# **Speed Hump Poll Results - Glenarden Road**

Date:	January 12, 2018
To:	Toronto and East York Community Council
From: Wards:	Acting Director, Transportation Services, Toronto East York District Ward 21, St. Paul's

Re: Traffic Calming Measures – on Glenarden Road, between Ridge Hill Drive and Aldburn Road – Evaluation for the installation of traffic calming measures (i.e. Speed Humps).

RE: Glenarden Road, between Ridge Hill Drive and Aldburn Road - Evaluation for installation of traffic calming devices.

- 1. Drawing No. 421G-2686, dated September 2017
- 2. Appendix A Letter from Toronto Paramedic Services, dated August 21, 2017
- 3. Appendix B Letter from Toronto Fire Services, dated September 28, 2017

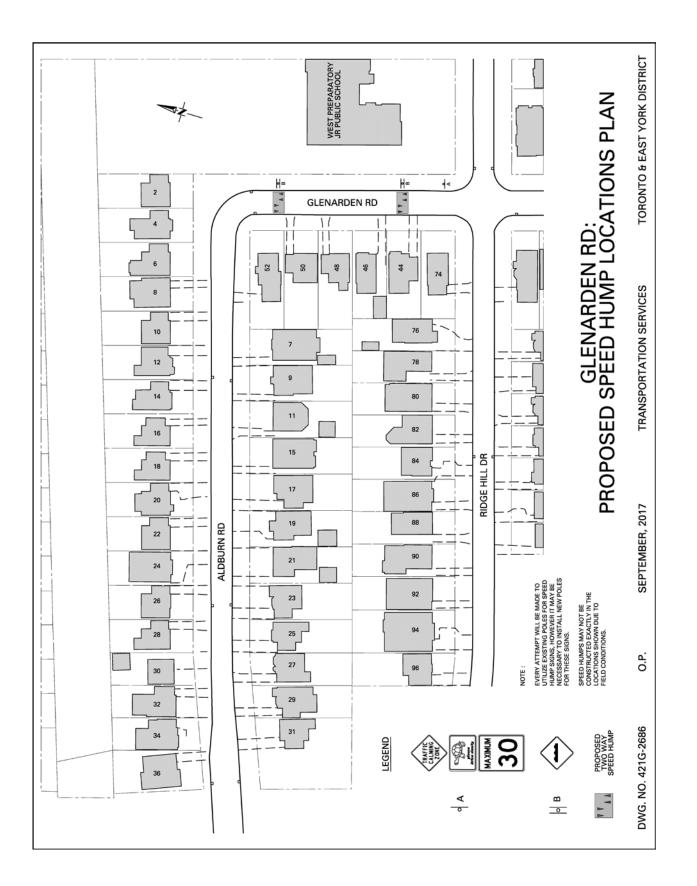
I have received and reviewed the proposal for installation of speed humps on Glenarden Road, between Ridge Hill Drive and Aldburn Road. I have the following comments:

As documented in the Traffic Calming Policy, Toronto Paramedic Services has concerns regarding the usage of traffic calming measures, specifically vertical obstacle measures such as speed humps. These have a negative impact on emergency call response times, travel times to hospital and on patient comfort during transport. This delay is cumulative with each obstacle and can directly impact patient outcome.

In addition to concern for patient outcome and safety it is noted that this proposal does not meet the Warrant Criteria as set out in the Policy. Therefore, Toronto Paramedic Services is opposed to the installation of traffic calming devices on Glenarden Road, between Ridge Hill Drive and Aldburn Road. It is important that the applicant fully understands the potential for delay in emergency response and that alternatives to vertical measures be considered and evaluated.

I am in receipt of the proposal for installation of traffic calming measures (speed humps) and provide the following comments.

Toronto Fire Services is supportive of initiatives that will improve the life safety for citizens of, and visitors to the City of Toronto. Our concern is that the physical calming measures being proposed may have a negative impact on emergency response to the area.

Fire Services does not support this speed hump installation as they would slow our responding vehicles and affect the delivery of service in the quickest possible manner. The effectiveness of our services is greatly impacted by time. The vertical restrictions imposed by a speed hump have a much greater effect on large fire vehicles than smaller passenger vehicles. Response time increase with every obstacle a fire vehicle encounters on route to an emergency incident. Although the increase at each hump may only be seconds, the cumulative effect can be a significant amount of time.

Fire Services recommends that non-physical measures (lower speed limits or prohibited turns) be implemented and evaluated before physical forms are considered. Desired results may be obtained without imposing a physical obstruction to emergency vehicles.
